Access Compliance Report

Public Rights-of-Way

(Curb Ramps)

Intersection ID: 21549	Main Street: S_TRYON_ST	Cross Street: SANDY_PORTER_RD	Location: NW
ADA ID: 66A823074519	Ramp Type: IslandPerp	Initial Pass/Fail: Fail	Overall Compliance: No
		Severity Score: 12.5

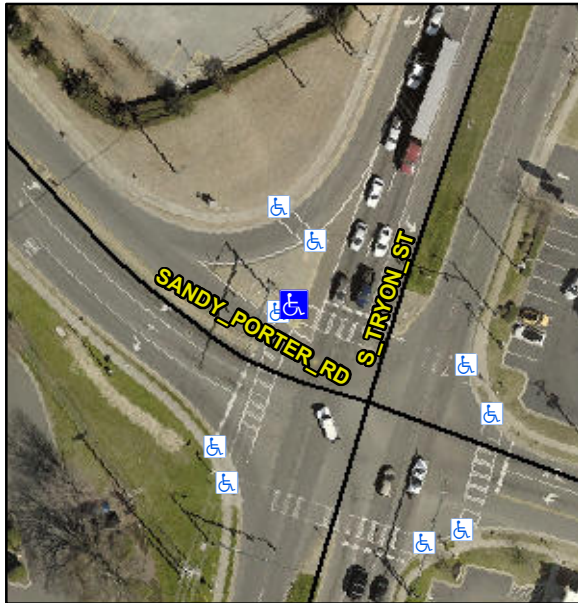
Not Found, R304.2.2

Compliance	Description	Data	Compliance	Description	Data
N/A	Ramp Length (in)	61.0	No	Ramp Slope (%)	8.9
Yes	Ramp Width (in)	48.0	Yes	Ramp XSlope (%)	0.8
N/A	Flare Type LT	N/A	N/A	Flare Type RT	N/A
N/A	Flare Slope LT (%)	N/A	N/A	Flare Slope RT (%)	N/A
N/A	Flare Traversable LT?	N/A	N/A	Flare Traversable RT?	N/A
N/A	Landing Length (in)	N/A	N/A	DWS Provided?	N/A
N/A	Landing Width (in)	N/A	N/A	DWS Contrast?	N/A
N/A	Landing Slope (%)	N/A	N/A	DWS Length (in)	N/A
N/A	Landing X Slope (%)	N/A	N/A	DWS Full Width?	N/A
N/A	Landing Curb? (Y/N)	N/A	N/A	DWS Offset (in)	N/A
N/A	Shared Landing?	N/A			
N/A	Gutter Ponding?	N/A	N/A	Gutter Slope (%)	N/A
N/A	Gutter Lip Ht (in)	N/A	N/A	Gutter X Slope (%)	N/A
N/A	Painted X Walk1?	Yes	N/A	Painted X Walk2?	N/A
	X Walk 1 Direction	To SE		X Walk 2 Direction	N/A
N/A	X Walk 1 Width (in)	109.5	N/A	X Walk 2 Width (in)	N/A
	X Walk 1 Slope (%)	2.3		X Walk 2 Slope (%)	N/A
	X Walk 1 X Slope (%)	2.4		X Walk 2 X Slope (%)	N/A

Remove & Replace Entire Ramp.
